## **Church refurbishment project**

# **Update to PCC on Refurbishment Feasibility Study**

Prepared by the Refurbishment Working Party on behalf of Blockley PCC and approved by the Standing Committee 27 November 2019

## Option 5 Rev B

TITLE  
Option 5RevB  
Proposed Plan

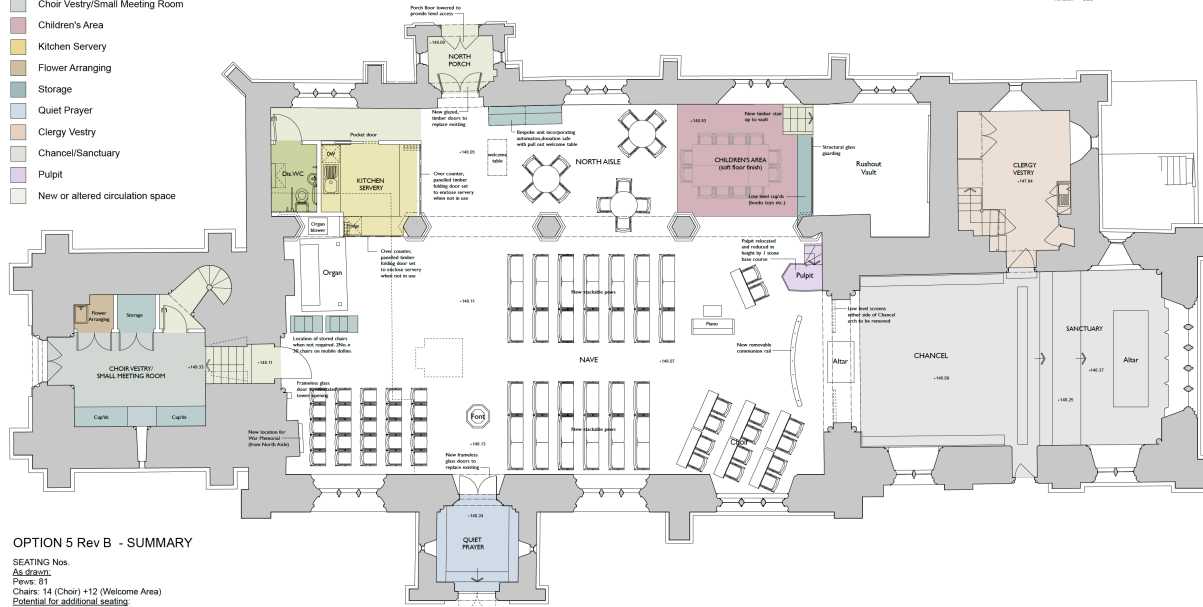
The labelling of the North East corner 'Children's area' implies that this is where children would be during all services. It is suggested that the label be removed from the drawing and that narrative explains how three possible areas for children could be used at different times.

1. The North East corner for when it is desired that children are involved as much as possible for part or all of the service.
2. The South West corner where they would still be in the main church but less distracting to the congregation.
3. In the tower room where there would be good sound isolation but there could be a vision and sound relay of the service. (The same relay could also be fed to the bell ringing chamber to meet one of the requirements of the bell ringers).

It has been suggested that storage of children's toys, craft stuff etc could be in cupboards on wheels which could also be used as screening for the area they are in. This would not work in the tower room, though, because of the steps through the arch.

The narrative would explain that the same areas would be available for meetings (1 and 2 only when the church was not open to the public). They should, therefore, have separate heating zones. 1 and 2 would both meet the requirement for an accessible meeting area.

An option considered by the PCC was to extend the floor of the Rushout tomb Westwards as far as the first pillar and enclose the whole area with glass screens. The drawbacks though, apart from the large cost, was the risk of damage to the monuments if that area were in regular use as well as the visual intrusion of the screens. One of the earlier drawings had the South West corner surrounded by foldable screens for the same

purpose. This would provide some sound isolation but, without a ceiling, would be far from perfect, be potentially unsightly and increase project costs. The tower room would seem to be a better option where sound isolation is needed unless the number of children expanded greatly. In which case, a construction in the NW corner could be done at a later date.

A second serving hatch on the East wall of the kitchen was added for occasions when large numbers of people would be present - e.g. interval of a concert. Despite the access to the North door being less obstructed by the removal of heating pipes and pews, there was still concern that congestion by the hatch could block access to the door. As that hatch is very wide, it is suggested that it be shortened at the North end so that access to the door and toilet is less likely to be an issue. This would also have the benefit of allowing the fitting of a wall cupboard in the NE corner of the kitchen.

The other issue with the second serving hatch is that the outside of it is an ideal place for notice boards. Folding hatches as shown in the drawing would prevent this use. An alternative would be a lift-up outward opening hatch. This would allow notice boards to be fitted to it and also give more servery width.
